Campus Point Stair Access Way
Project No. FM110220S/987767

Addendum No. 3

ADDENDUM NUMBER 3

Campus Point Stair Access Way

SK-L01

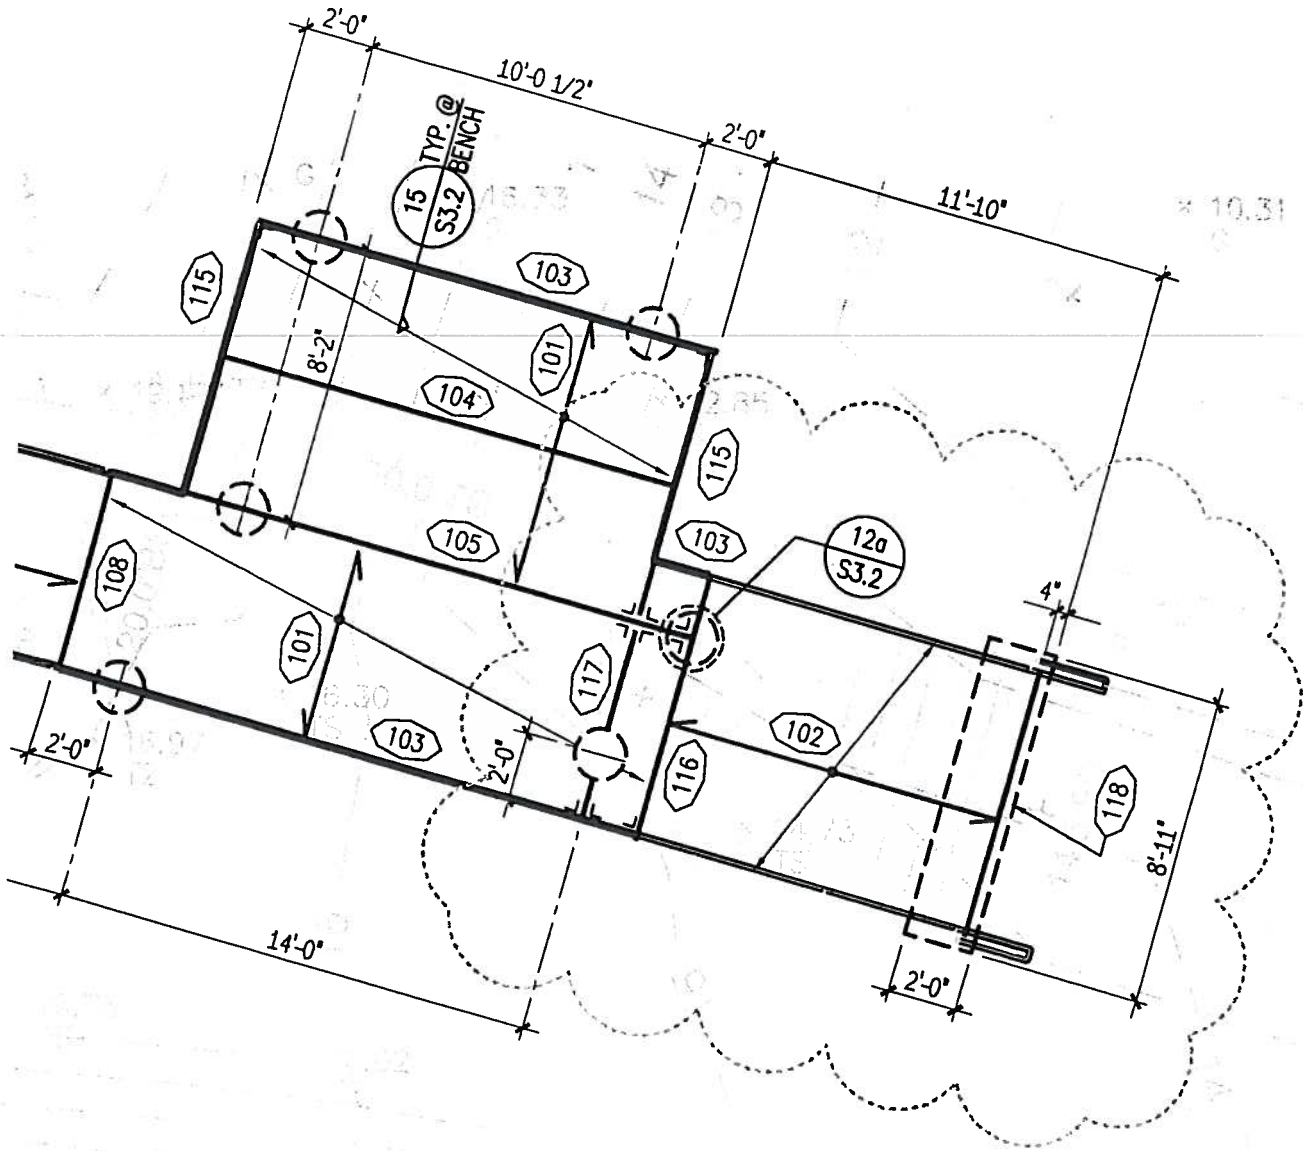
1. Drawing No. S1.1, General Notes
Replace General Note C.1.A, Drilled Piers, in its entirety with revised note per attached sheet SK-L01 (see Attachment 1).

2. Drawing No. S1.1, General Notes
Replace General Note C.2.A, Shallow Foundations, in its entirety with revised note per attached sheet SK-L01 (see Attachment 1).

C. FOUNDATIONS

1. DRILLED PIERS

A.) VERTICAL CAPACITY: ON THE BASIS OF OUR UNDERSTANDING OF THE SUBSURFACE CONDITIONS, USE CAST-IN-PLACE PIERS DESIGNED AS FRICTION PIERS TO SUPPORT THE PROPOSED STAIRWAY. ALLOWABLE SIDE FRICTION VALUES OF 200 PSF PER FOOT OF DEPTH AND 1000 PSF PER FOOT OF DEPTH CAN BE ASSUMED FOR THE MARINE TERRACE DEPOSITS AND CLAYSTONE BEDROCK, RESPECTIVELY. WHERE DRILLED PIERS ARE USED (AND WHERE PRACTICAL), THEY SHOULD BE EMBEDDED A MINIMUM OF 5 FEET INTO THE CLAYSTONE BEDROCK OF THE SISQUOC FORMATION.

C. FOUNDATIONS

2. SHALLOW FOUNDATIONS

A.) ALLOWABLE BEARING CAPACITY AND SETTLEMENT: PLANS FROM UCSB INDICATE THAT A RELATIVELY LARGE LANDING OR PLATFORM IS PROPOSED IN THE AREA NORTH OF THE BLUFF SLOPE. BECAUSE DRILLED SHAFT EXCAVATIONS MAY BE DIFFICULT TO CONSTRUCT IN THIS AREA, IN OUR OPINION, SHALLOW FOUNDATIONS MAY BE A MORE PRACTICAL FOUNDATION ALTERNATIVE TO DRILLED PIERS IN THE AREA NORTH OF THE BLUFF SLOPE. IF SHALLOW FOUNDATIONS ARE USED, THEY SHOULD BE DESIGNED FOR AN ALLOWABLE BEARING CAPACITY OF 1,500 POUNDS PER SQUARE FOOT AND THE FOOTINGS BE UNDERLAIN BY A MINIMUM OF 2 FEET OF COMPACTED FILL MATERIAL PLACED AS DESCRIBED IN THE SOILS REPORT. THE FOOTINGS SHOULD BE AT LEAST 2 FEET WIDE AND BE EMBEDDED AT LEAST 12 INCHES BELOW THE LOWEST ADJACENT GRADE. THE SETTLEMENTS RESULTING FROM STATIC FOUNDATION LOADS SHOULD GENERALLY BE LESS THAN APPROXIMATELY 1-INCH TOTAL AND APPROXIMATELY 1/2-INCH DIFFERENTIAL IN 30 FEET ALONG THE BRIDGE ABUTMENT OR WING WALL FOUNDATION.

SK-L02

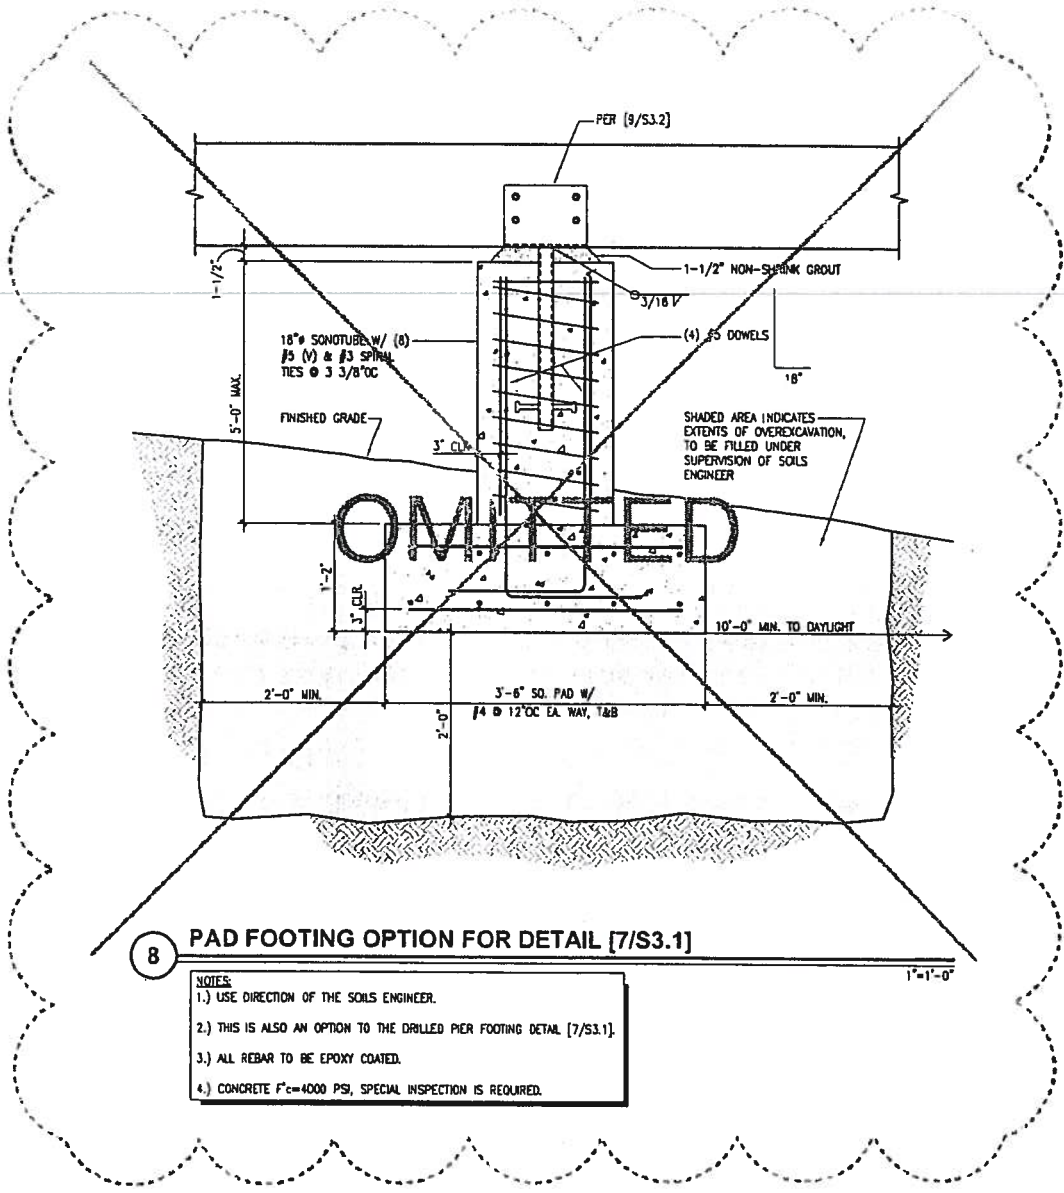
3. Drawing No. S2.1, Deck Framing Plan
Revise portion of the Deck Framing Plan per the attached sheet SK-L02 (see Attachment 2)
4. Drawing No. S2.1, Deck Framing Plan
Revise detail reference “4/S3.1” to read “3Y/S3.1”.
